Application No. 10/628,520
Amdt. Dated August 23, 2004
Reply to Office Action of April 21, 2004

REMARKS/ARGUMENTS

Application No. 10/628,520
 Amendment date: 8/23/2004
 Reply to Office Action of 4/21/2004
Annotated Sheet Showing Changes

FIG. 4

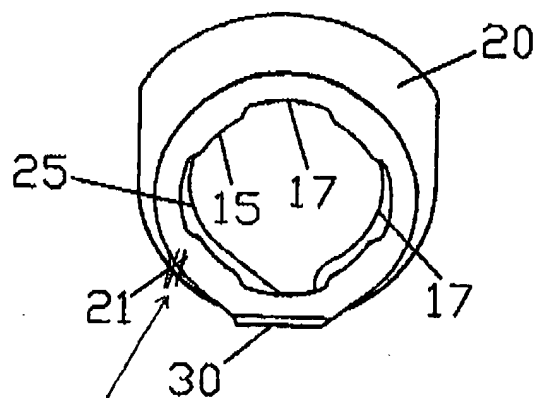
Furthermore, Applicant submitted herein a proposed correction of Fig. 4 to correct a marking error on part 21. Applicant requests the Examiner's consideration and entering of the corrected drawing.

*Change marking
 to the right
 position*
